**ZONING CASE
PZ-PUD-2020-50002**

Planning & Zoning Commission Staff Report

Case# case PZ-PUD-2020-50002

Proposed Site Plan

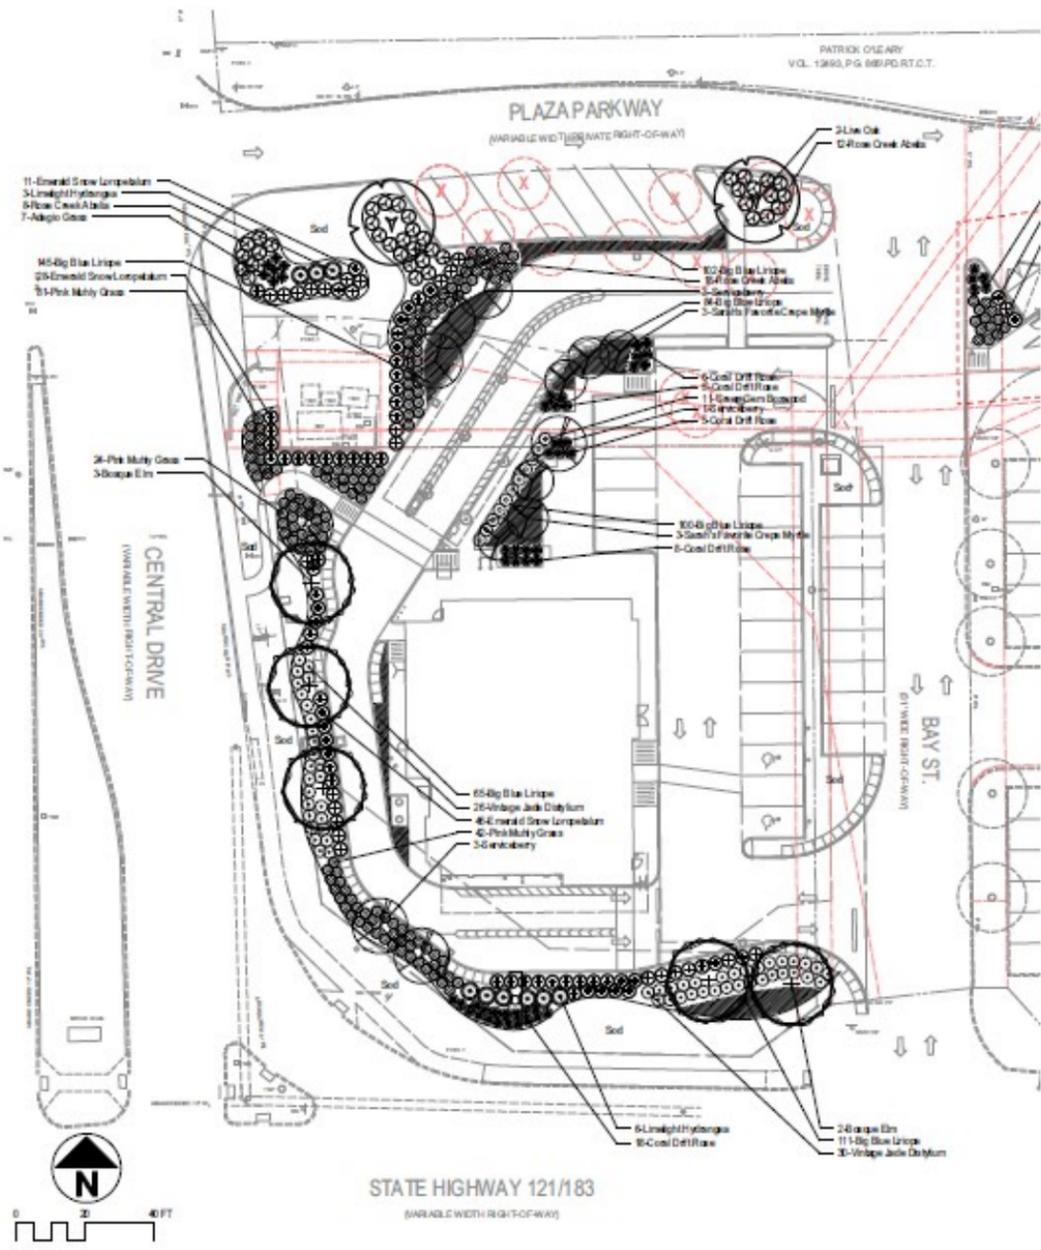
- Recommend modification of proposed PUD Standards: Section 11. Development Standards d) Roof top mechanical equipment to state the following:
 - Roof top mechanical equipment shall be screened from view of adjoining roadways including the main lanes of SH 121/183.
- Provide lighting plan per Section 4.18.I (9) which states:
 - The site plan shall provide a lighting plan detailing the layout of fixtures, elevations, lamp type, and average illumination of each fixture.
- Provide a traffic impact analysis per Section 4.15.B (4) which states:
 - The proposed development will not generate more traffic than the streets in the vicinity can accommodate without congestion, and the development will not overload utilities as determined by the City Engineer.
- The property will have to be replatted prior to issuance of a Certificate of Occupancy.
